Final Product/Process Change Notification

Document #:FPCN25336XA

Title of Change:	Qualification Assembly site in UTAC Thailand for FSA3157L6X and NC7SZ66L6X
Proposed First Ship date:	21 Mar 2024 or earlier if approved by customer
Contact Information:	Contact your local onsemi Sales Office or mitch.paris@onsemi.com
PCN Samples Contact:	Contact your local onsemi Sales Office. Sample requests are to be submitted no later than 30 days from the date of first notification, Initial PCN or Final PCN, for this change. Samples delivery timing will be subject to request date, sample quantity and special customer packing/label requirements.
Additional Reliability Data:	Contact your local onsemi Sales Office or Lalan.Ortega@onsemi.com
Type of Notification:	This is a Final Product/Process Change Notification (FPCN) sent to customers. FPCNs are issued 90 days prior to implementation of the change. onsemi will consider this change accepted, unless an inquiry is made in writing within 30 days of delivery of this notice. To do so, contact PCN.Support@onsemi.com

HANA Thailand

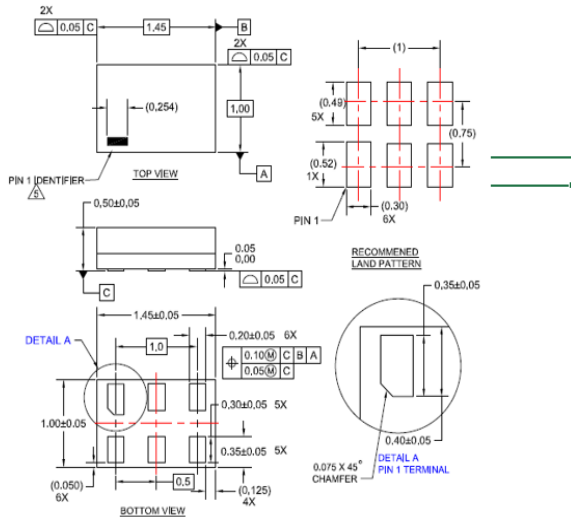
Dimension	HANA Thailand (existing)			UTAC Thailand (new site)			Remark
	Min	Nom	Max	Min	Nom	Max	
A	0.45	0.50	0.55	0.58	0.63	0.68	UTAC thicker than HANA
L	0.25	0.30	0.35	0.20	0.25	0.30	Outer lead smaller than existing but still can use the same footprint.
L1	0.30	0.35	0.40	0.25	0.30	0.35	Outer lead smaller than existing but still can use the same footprint.
K	-	0.05	-	-	0.10	-	Still can use the same footprint.
